project: 241 – 245 Pennant Hills Road, Carlingford

Response to Council Submission

This statement has been prepared in response to the submission made by City of Parramatta Council in response to the Planning Proposal at the above address (PP-2022-376) dated 22 June 2022

**Re: No 241-245 Pennant Hills Road Carlingford – Planning
Proposal**

Figure 2. West perspective looking northeast

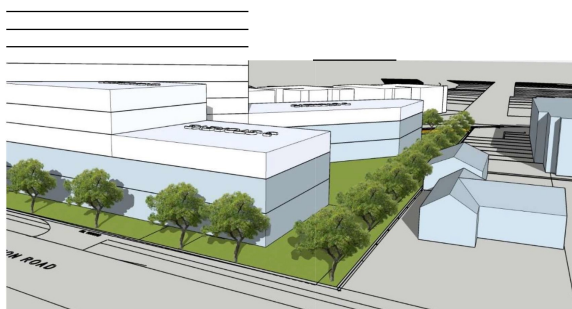
The through-site link has been relocated against the western boundary. It will be 9m wide, which will allow for a deep soil zone and path access running north to south from Pennant Hills Road to Felton Road providing separation between the site and adjacent low density residential development.

The proposed through-site link should be designed as a 24/7 publicly accessible space with equitable access and be included as part of any future Planning Agreement negotiation with Council (further details provided in Section 3 of this submission).

Kennedy Associates have no particular comments on Council's alternative scheme, except for those included above in relation to the alternative through site link location and design.

The photos are taken from the vicinity of the proposed tower component at the subject site

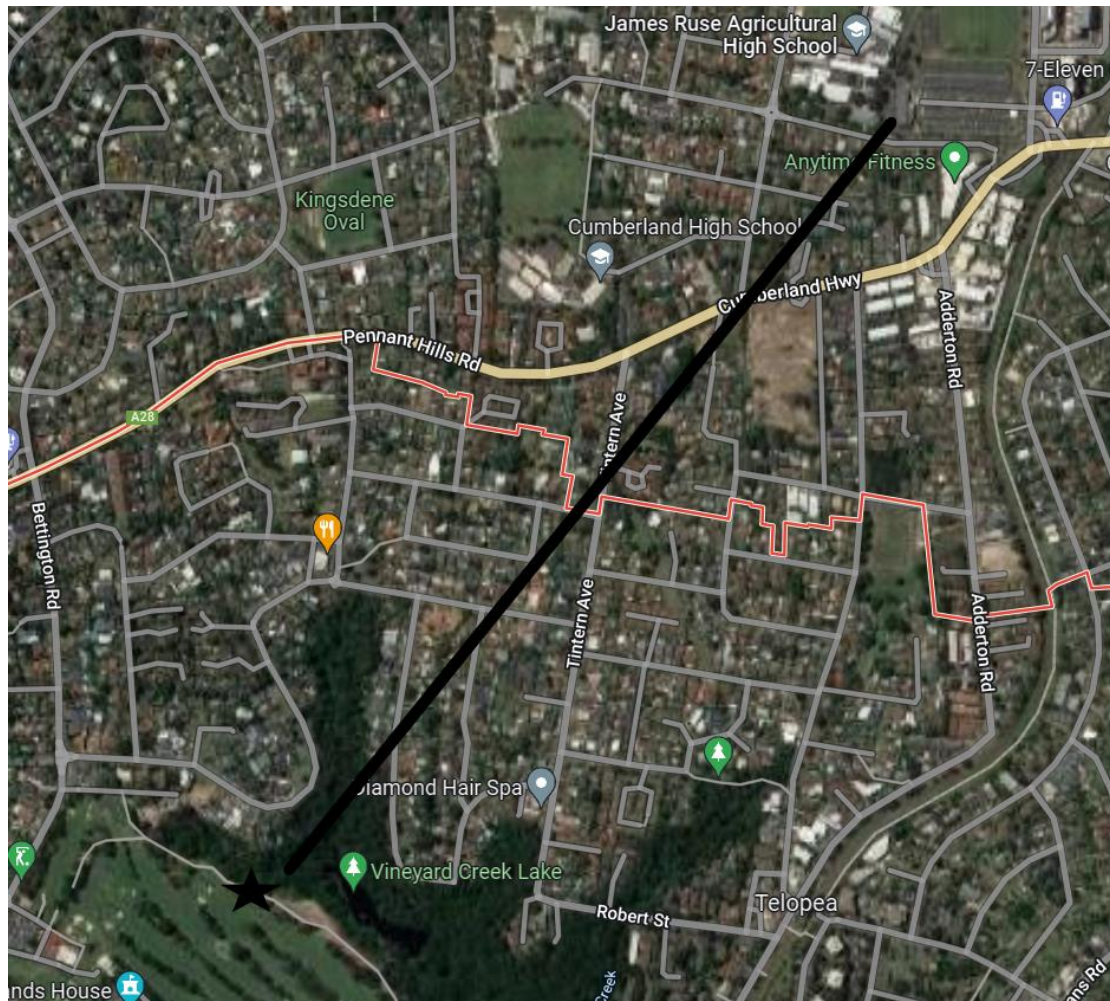
We do note that this concern relates to the commercial agreements Transgrid has with their customers, however some of these customers do include sensitive Federal Government agencies. We welcome your response on these issues.

It is understood that the telecommunication network functions by relying on a series of overlapping zones. In the instance that a facility cannot provide coverage, then another nearby facility should be able to compensate. A similar tower is located within the grounds of Oatlands Golf Course and would provide coverage towards the southern side of the site. No disruption of the connectivity between facilities is likely (see below). It is assumed that other facilities also exist to the south-east of the site.

In addition, I understand that the advances in technology are less reliant on the antiquated infrastructure which exists in Felton Road. I note that no mention has been made of this or any alternate solution being forwarded by TransGrid, if indeed a problem exists.

Unfortunately, as the applicant has no access to technical information about the tower and network, a limited layman's response is provided. Certainly, the applicant is of the view that no changes are warranted to the design based on TransGrid's submission.
